**Re: Panoche Energy Center, LLC follow up December 18, 2020 meeting with EPA on
UIC Permit No. R9UIC-CA1-FY17-2R**

Through this letter, Panoche Energy Center, LLC (PEC) provides its comments on the draft Underground Injection Control permit R9UIC-CA1-FY17-2R (Draft Permit) under docket number [EPA-R09-OW-2021-0147](#) to the U.S. Environmental Protection Agency (EPA), Region 9. The Draft Permit would authorize PEC to continue operating four (4) Existing Wells, known as IW1, IW2, IW3 and IW4, and construct and operate two Potential Wells, IW5 and IW6 once all permit conditions pertaining to the wells have been met for PEC's power generation facility (the "Facility"). In addition, the Draft Permit would require PEC to install a monitoring well to assess subsurface conditions associated with identified underground sources of drinking water (USDW).

This letter provides PEC's comments on the technical terms and conditions in the Draft Permit, and in particular, on the proposed monitoring condition associated with Silver Creek #18 well.

Figure 1

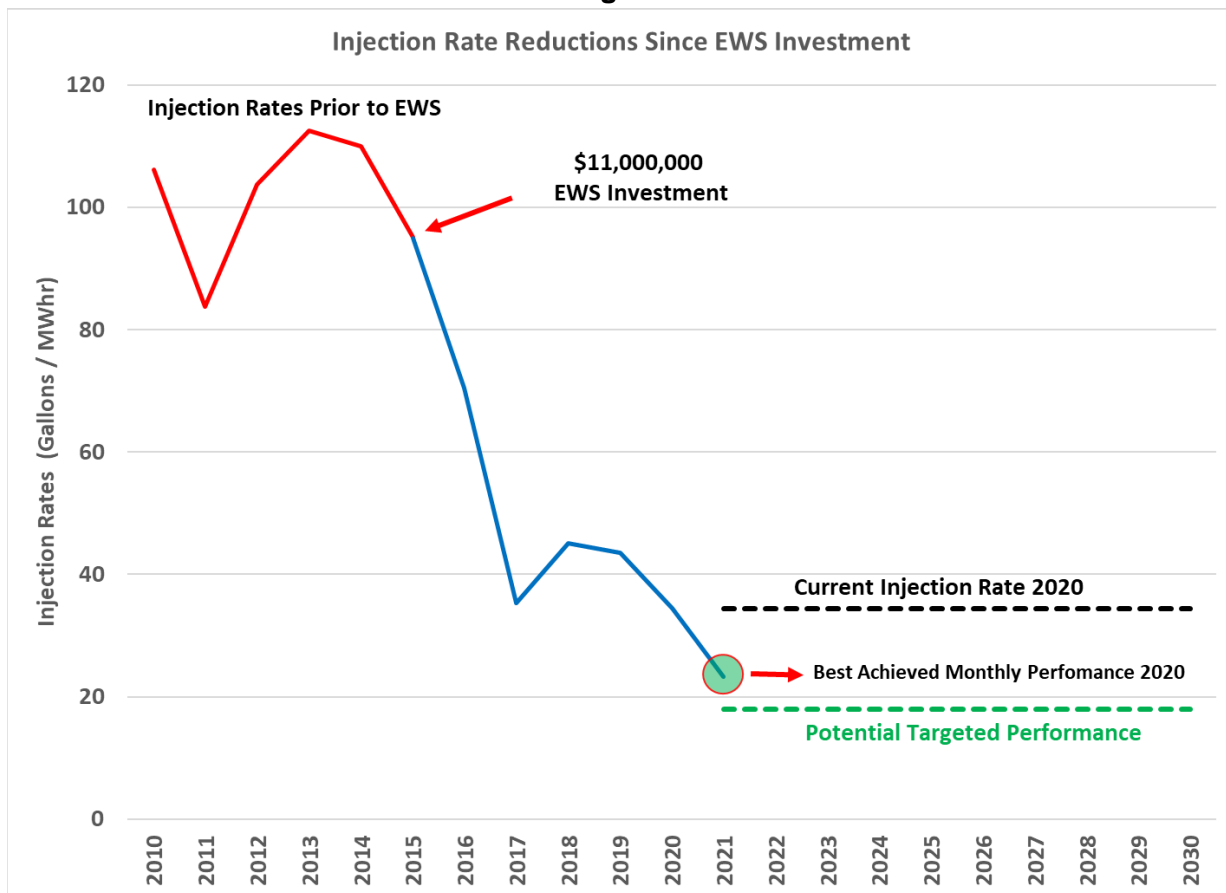
Prior to the EWS being commissioned, injection rates on a gallon per megawatt hour (“gal/MW hr”) were as high as 112 gal/MW hr. Since the EWS was commissioned, injection rates have decreased significantly. Year-to-date in 2020, injection rates have reduced by approximately 70% to 34 gal/MW hr. Through continued optimization the Facility has been able to achieve injection rates as low as 22 gal/MW hr. See Figure 1 below.

Figure 2

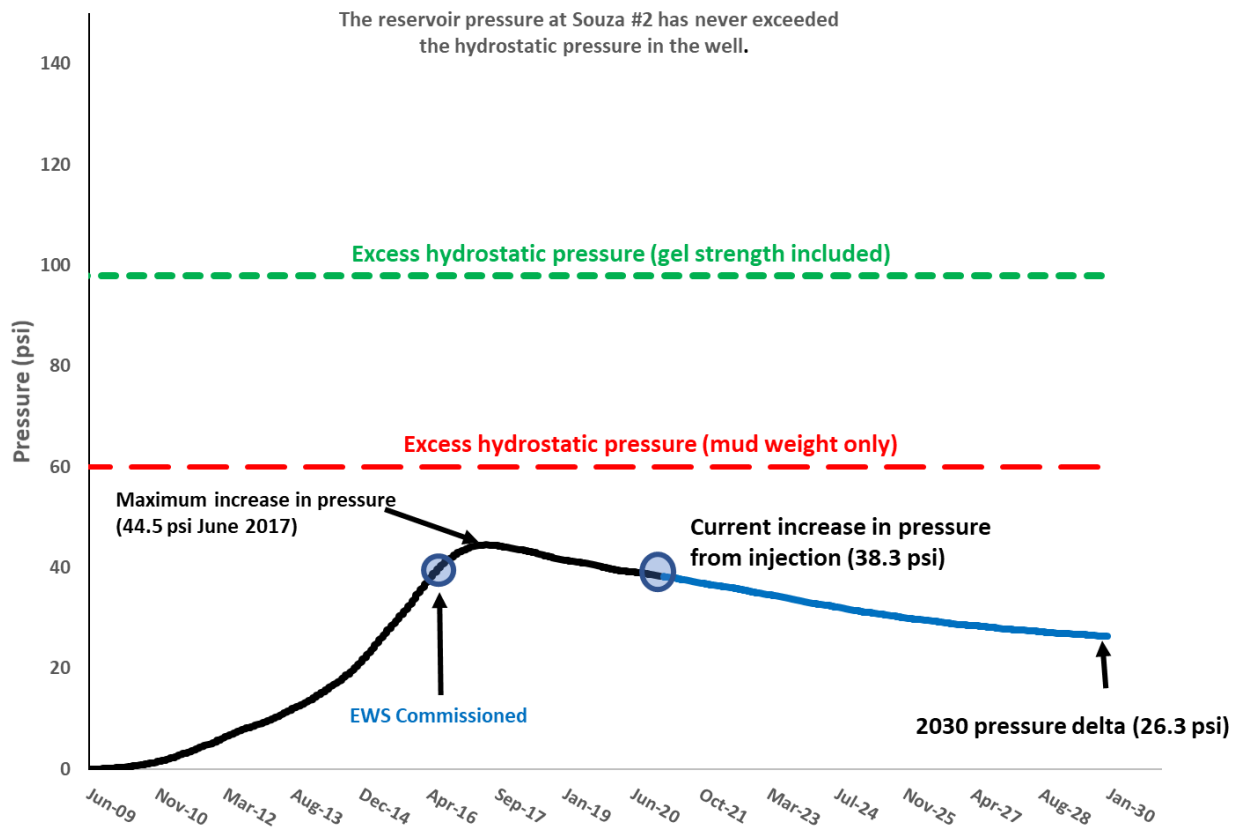
PEC's September 2020 Analysis for the EWS and reduced injection volumes (Figure 2) shows that the mud column hydrostatic pressures in Souza #2, Silver Creek #18 and England #1-31 (Figures 3, 4, and 5, respectively) have always been in excess of the maximum reservoir entry pressures. In addition, the EWS evaluation also shows that each well experienced its highest increase in reservoir pressure in 2017; and since then, induced pressure within the reservoir has and will continue to decrease, due to lower injection volumes, throughout the life of the permit. These improvements are a direct result of the EWS commissioning in 2016.

Souza #2 Pressure History and Expected Future Pressure Decreases

The reservoir pressure at Souza #2 has never exceeded the hydrostatic pressure in the well.

Figure 3

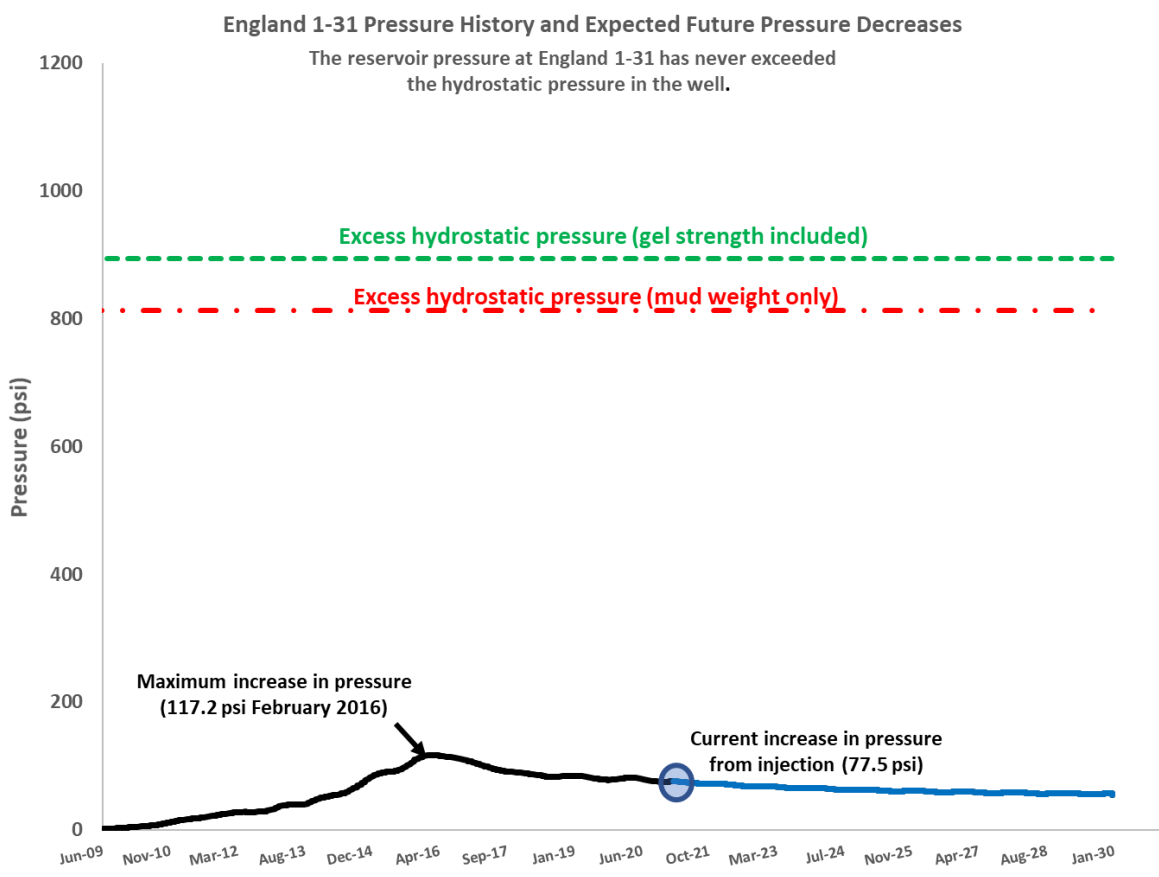
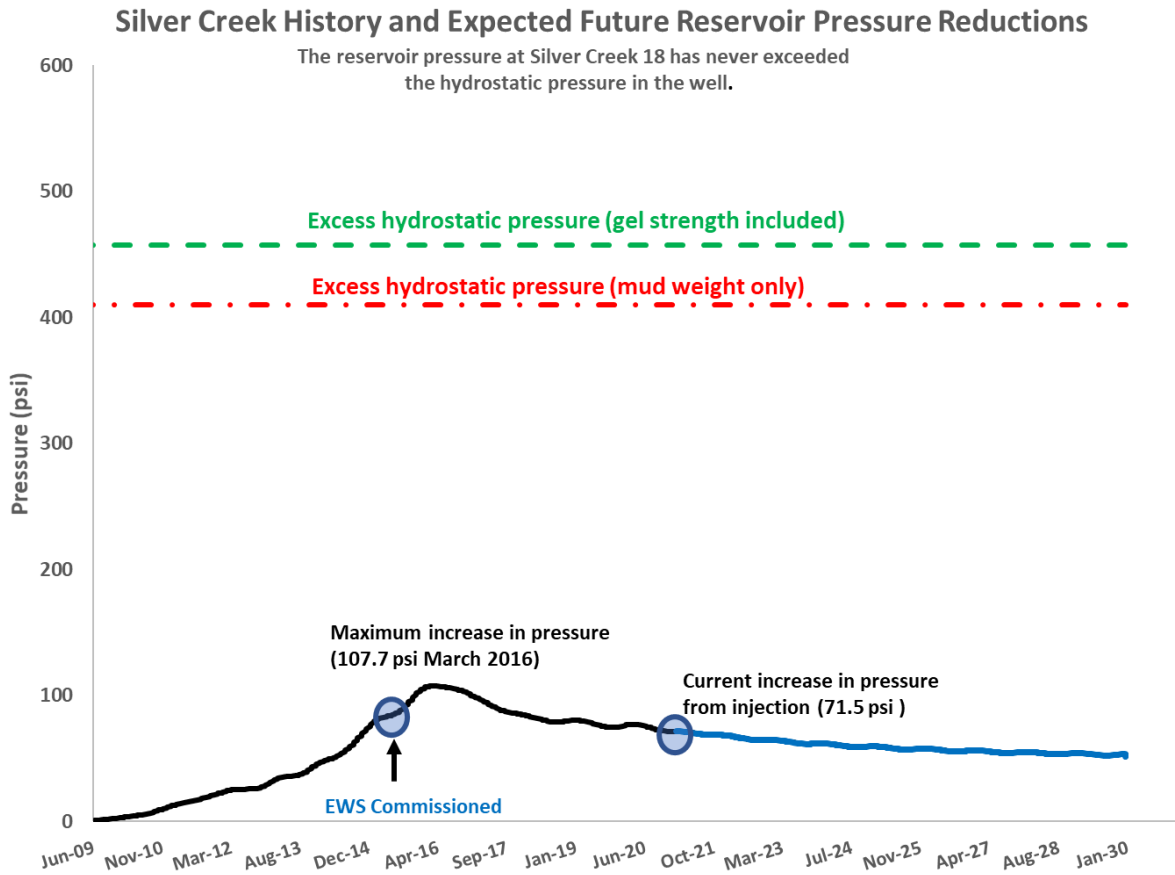
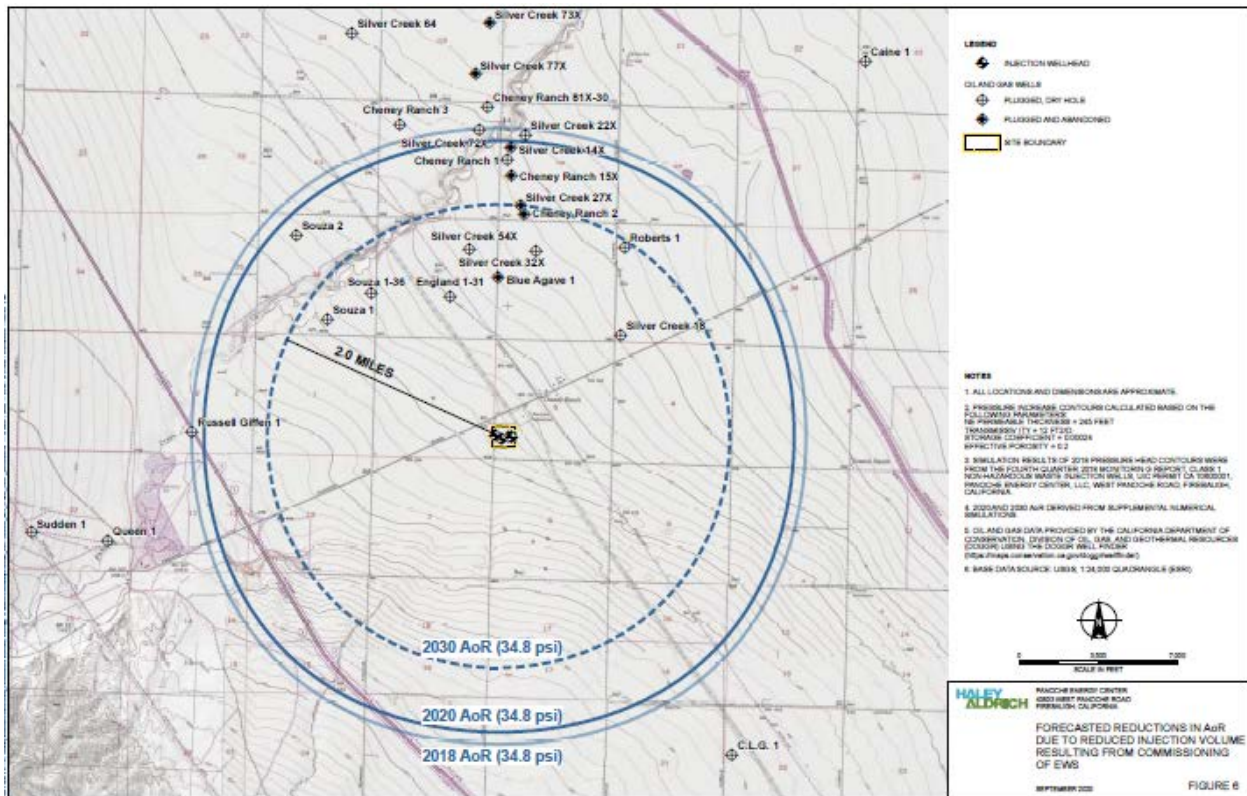
Based on the September 2020 Analysis, the current reservoir pressure differential (above initial pressure) at Souza #2 is 38.3 psi (see Figure 2 below). This pressure differential will continue to decrease through the permit term. Figure 2 shows the effect of the EWS on the differential hydrostatic pressures exerted at Souza # 2; Figure 3 shows the effect of the EWS on the differential hydrostatic pressures exerted on at the England # 1-31 well; and Figure 4 shows the effect of the EWS on the differential hydrostatic pressures exerted at Silver Creek #18.
